VILLAGE OF WAUNAKEE / TOWN OF WESTPORT JOINT PLAN COMMISSION Town of Westport Community Room 5387 Mary Lake Road February 11, 2020 6:00 PM

TITLE: Discuss and Take Action on a Request for Site Plan Approval, Kraemer Development LLC, Mixed Use Commercial, Lot 2 Woodland Crest Development

Re: Response to Consultant Comments – Lot 2 of Woodland Crest

Re: Kraemer Development Site Plan

BUILDING **ELEVATIONS** A6.01

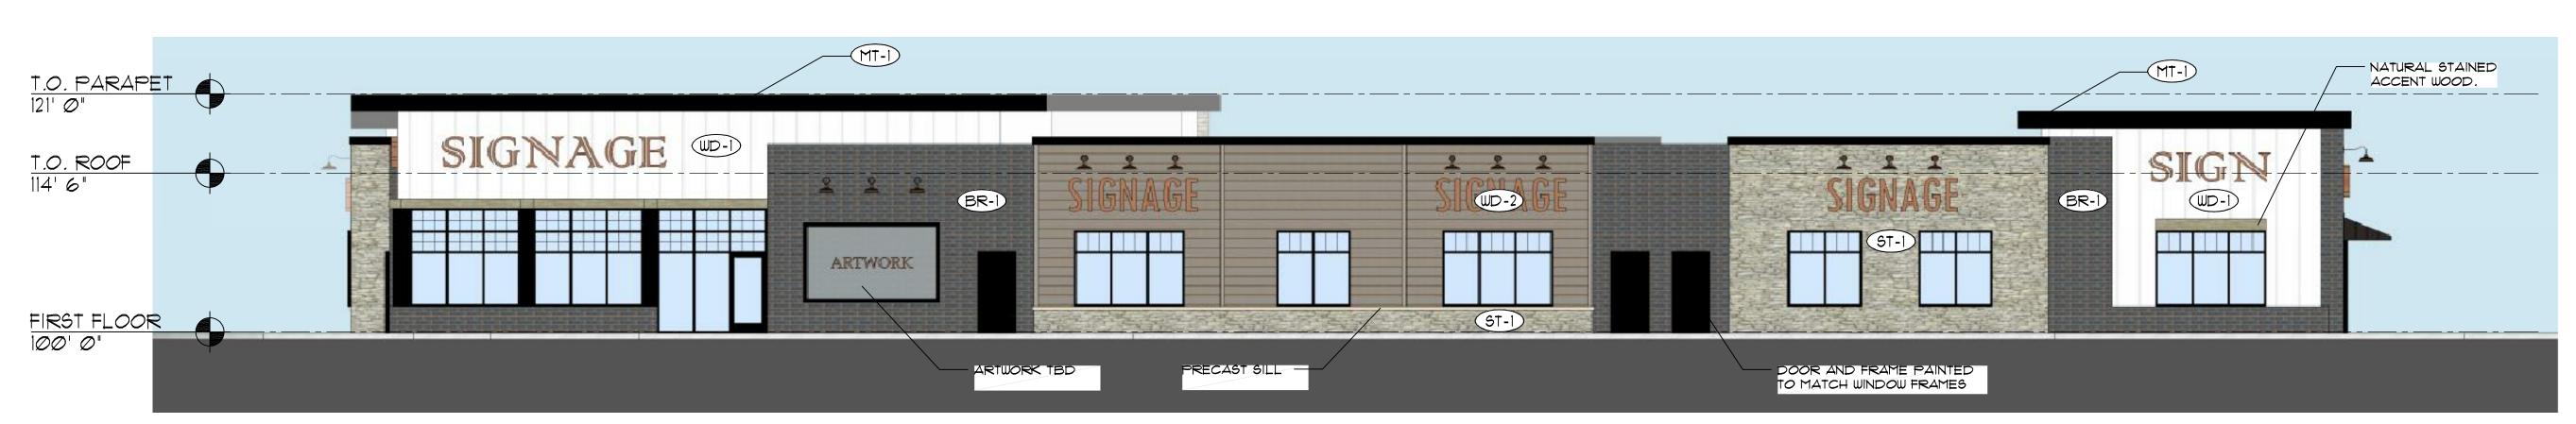
- **9. Building visual relief:** A request was made by Graef for a building section to verify the building does not appear too monolithic or flat. Please see the dimensioned floor plan which shows the various articulation in the exterior. Ok

- 1. The proposed building is within the allowable building height limitations.
- 2. It appears that there are no roof top mechanical units. If there are any roof top penetrations or equipment please show locations and appropriate architectural treatment.
- 3. Encourage applicant to consider additional sun screens or awnings for sunlight control at storefronts and add additional scale to building elevations.
- 4. The signage will need to be submitted with specific sizes when requesting signage permits. Current plans and elevations show sign zones only.
- 5. The materials proposed are acceptable. Please submit samples for final approval.
- 6. To ensure that buildings elevations provide adequate visual relief and do not appear too monolithic or flat, please submit a wall section illustrating the detail of and vertical alignment of windows, doors and storefronts.

C_{1.0}

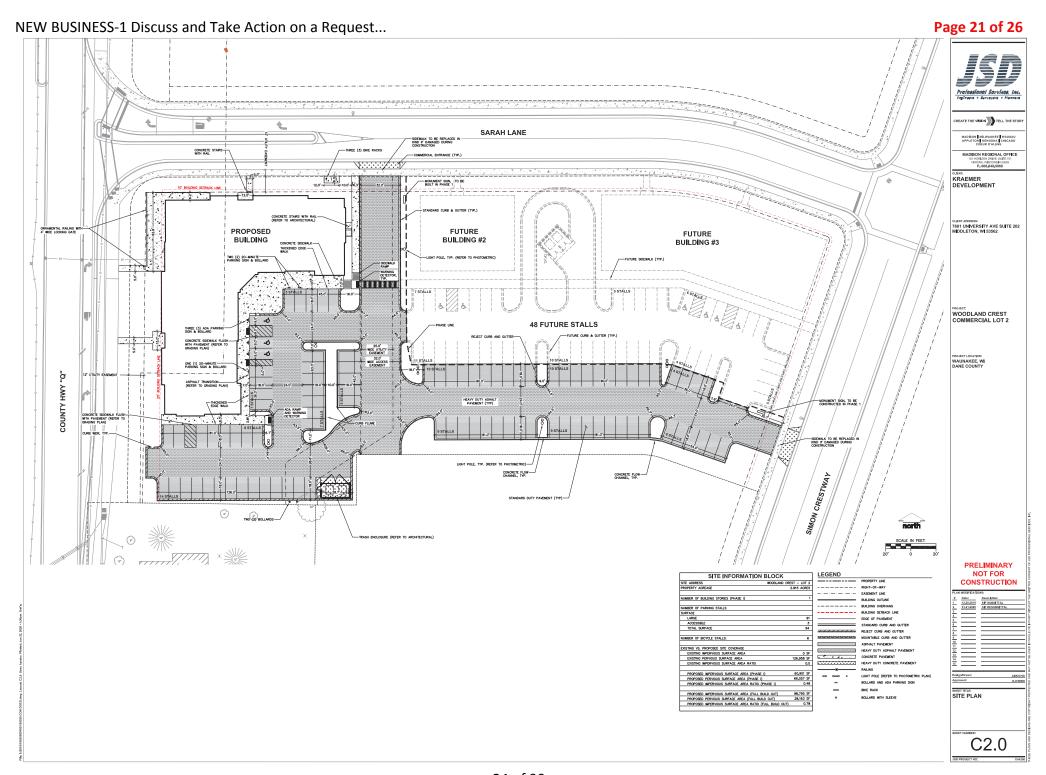
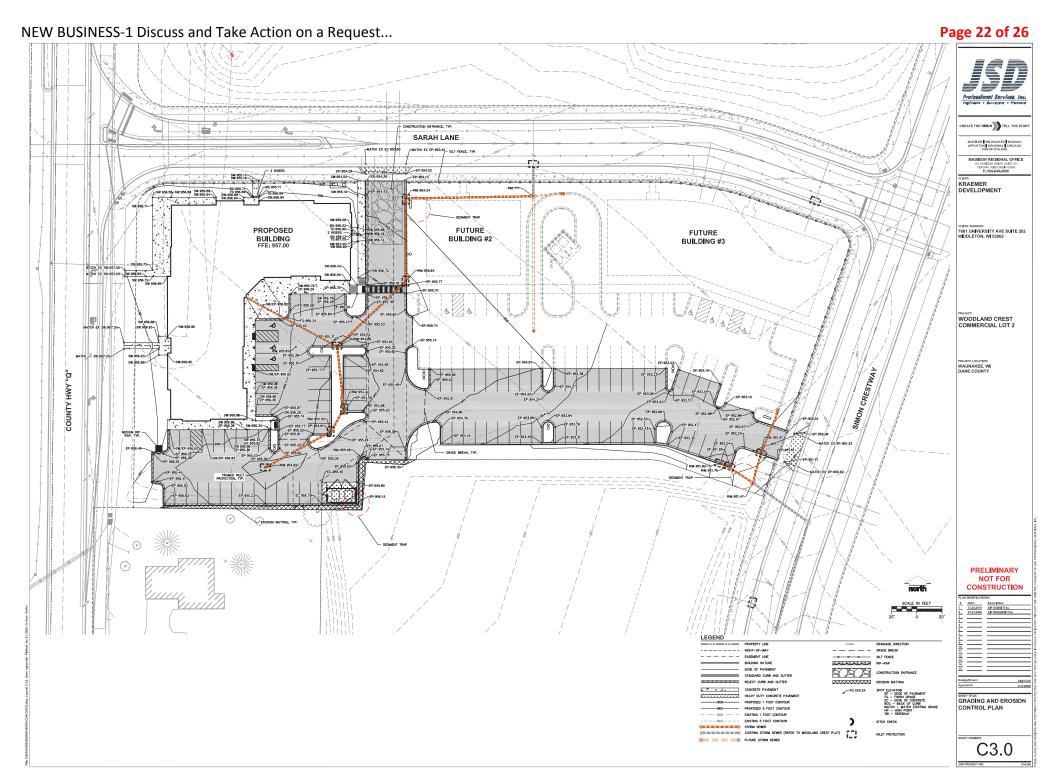
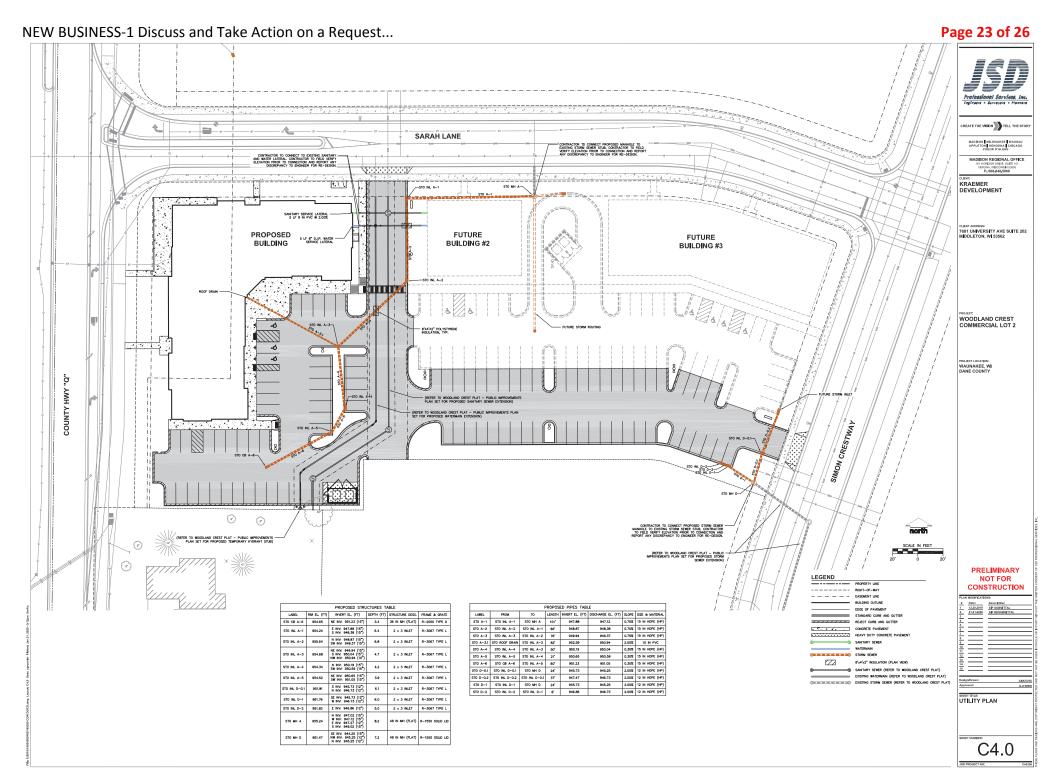
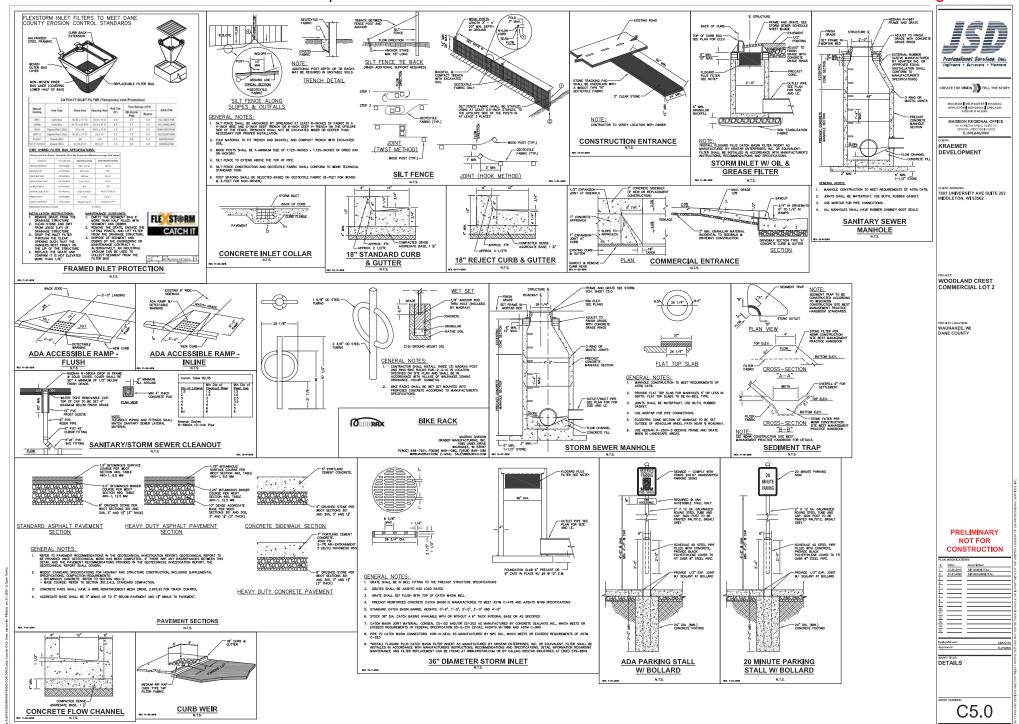
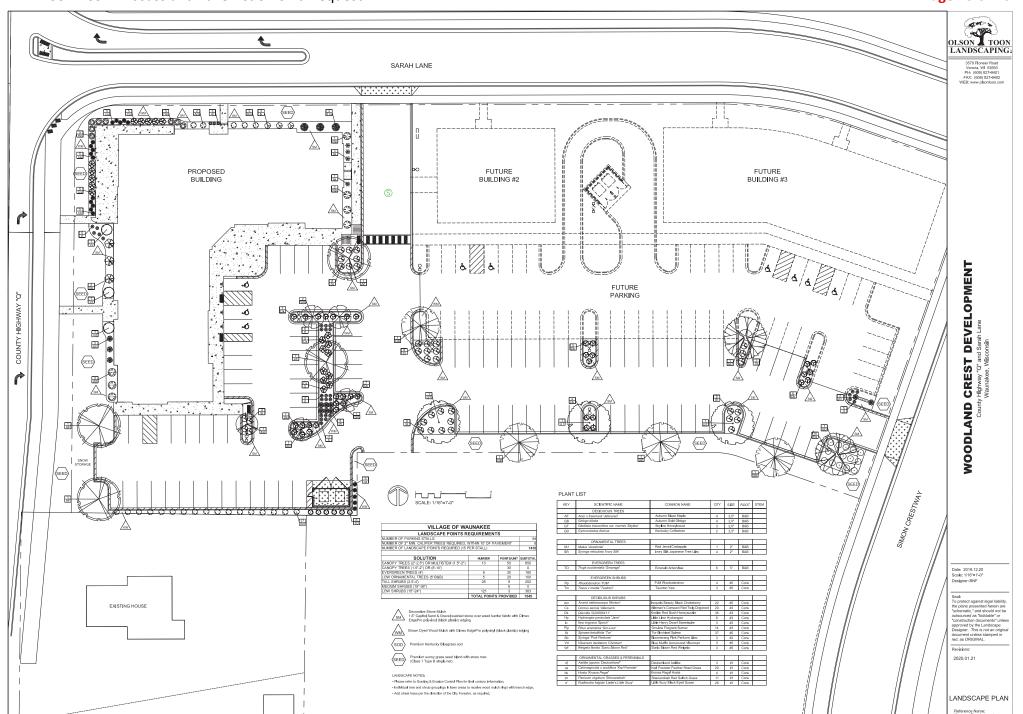
On the proposed plan, 92 stalls are intended to be provided under the first phase of construction, with 49 future stalls when future Buildings 2 and 3 are constructed. Based on the square footage of all buildings, and assuming the three buildings are commercial-only spaces, the required number of stalls for phase 2 is 74, and the required number of stalls for all buildings shown is 145 as required by the Village Ordinances. Overall, the site will be four stalls short, but there appears to be adequate parking for the first phase. Three accessible stalls are provided for the initial phase, which seems to be one short. The drawing shows potential accessible stalls at the south end of the building, but no markings are shown. If the stalls there were intended to be accessible, the drawings should indicate this.

The applicant should add a stormwater collection inlet in the east parking lot where water appears to be trapped by a proposed tree island. If the curb at this island is intended to be a pass-through curb, better detail should be provided on the plans. Finally, better detail is needed at the south side of the site where the development abuts the residential property. For one, the curb line and dumpster are located very close to the lot line; this should be dimensioned for consideration. Second, better details should be provided showing how grades will be blended between the two properties and how surface water runoff will be managed.

The parking stalls along the south property line nearest Highway Q are very close to the property line – by my estimate the back of curb appears to be offset from the property line 1.4 to 3.2 feet. This is much too close. The planting plan shows bushes in this strip that grow to 4-5 feet in diameter, but there's not enough space for anything to survive without encroaching on the adjacent lot and/or the parking stalls. Though not enforceable as part of the adopted GDP document, the developer's GDP indicated that there would be 100% screening next to residential uses for headlights using fencing, berm, and/or plantings. Further, the standard village ordinance addressing the design of parking (133-995(3)b.) requires a 25-foot setback if next to a residential district lot line and a 5 foot setback if next to a non-residential lot line. The residential lots along Highway Q are planned for commercial use, and the relationship between this lot and the planned residential use of Lot 1 is built into the GDP with the assumption of just a typical 5 foot setback, in my opinion. I recommend at least 5 feet from the back of curb to the property across the entire south lot line to allow for plantings and other screening as appropriate.

- 1. Setback to parking adjacent to building 1 on the SW side of the site: The attached exhibit provides a solution as to how the 5' pavement setback could be met on the south property line if required by staff. We'd recommend keeping the landscape screening (chokeberries) as proposed but work to shift the parking lot north approximately 3.5'. In doing so, the east/west sidewalk adjacent to the building would be omitted. The door on the south side of the building would remain for unloading of goods. Parking lot pavement would be flush with the doorway stoop for dolly convenience. Ok
